41, 45, and 47 West Main Street Façade Remodel Changes Project Narrative

CITY OF MESA
ENGINEERING DEPARTMENT
DOWNTOWN FACADE IMPROVEMENTS
41, 45, 47 WEST MAIN STREET
MESA, AZ 85201

**Design Review Board – Work Session Minutes
August 8, 2017**

E.1. DRB17-00114 41 W. Main St. Façade Improvement

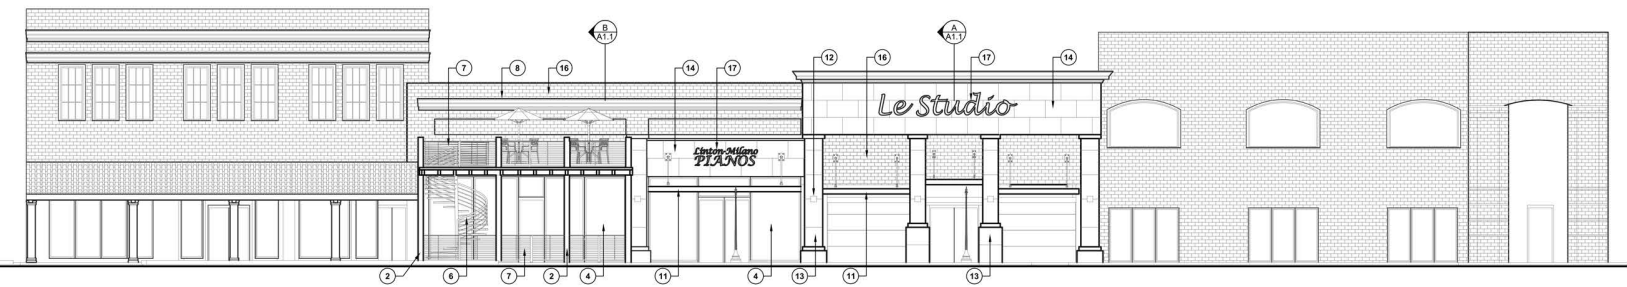
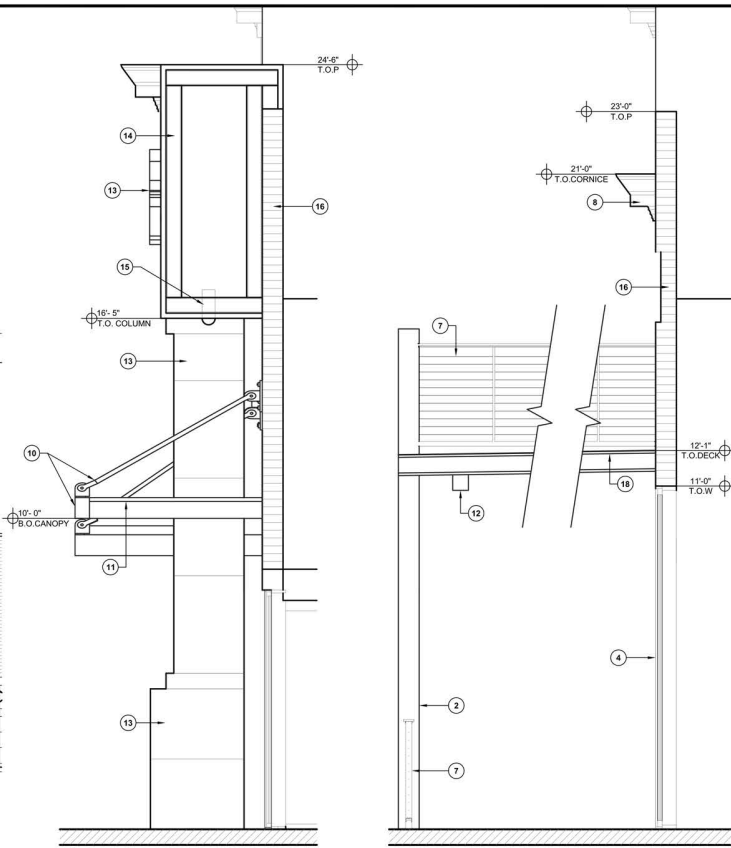
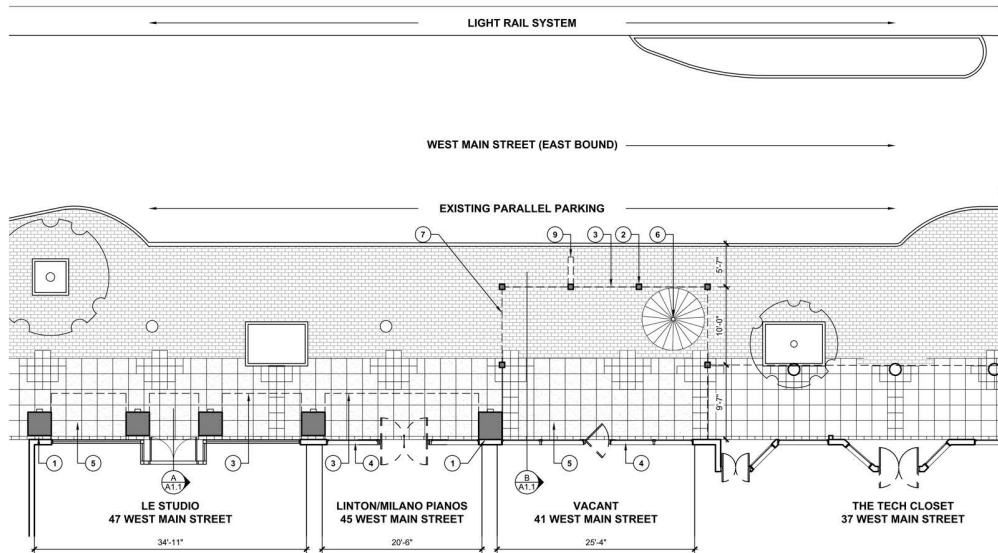
- Liked the intersection of canopies
- Liked the idea of adding more color
- Felt that the canopies don't stand out enough

- Confirmed that the canopies are somewhat held back to the building, and was concerned that not much shade is provided
- Confirmed that the deepest point in the canopy shade projection is 6', and that the owner did not want columns or anything else to interfere with the storefronts
- Suggested a free-standing shade structure in the void between 45 W. Main Street and 47 W. Main Street
- Didn't like the way that the buildings are clad

- Like them all, surprised how modern this component is in relation to the other proposals
- Concerned that Milano's was getting lost in the design, as there were no prominent features proposed for that building
- Suggested elevating canopy where it doesn't touch, to overlay, to appear like it does
- Suggested adding color to the existing black colors
- Liked the intersection of canopies
- Liked the modern look of the canopies
